SERVICE ADVISORY

NO.: 2185 Rev B

TO: Garmin Integrated Flight Decks and GTN Navigators Owners and Operators
DATE: July 25, 2023
SUBJECT: Abort Approach
REVISION B: Added GTN Resolution

Figure 1 – GTN VFOM

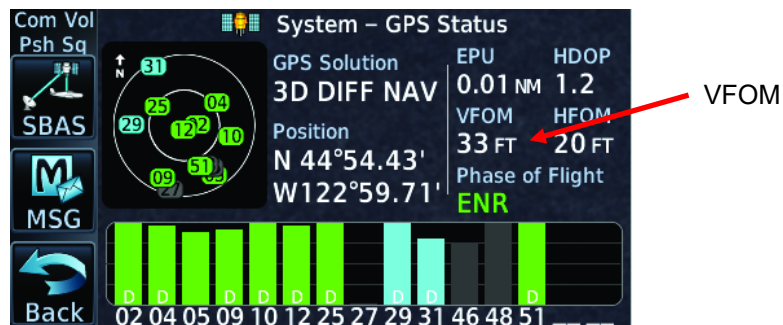
Before loading a GPS-based approach (indicated as LNAV-only on the selection page) make sure the VFOM (Vertical Figure of Merit) value on the GPS Status page is less than 106 feet.
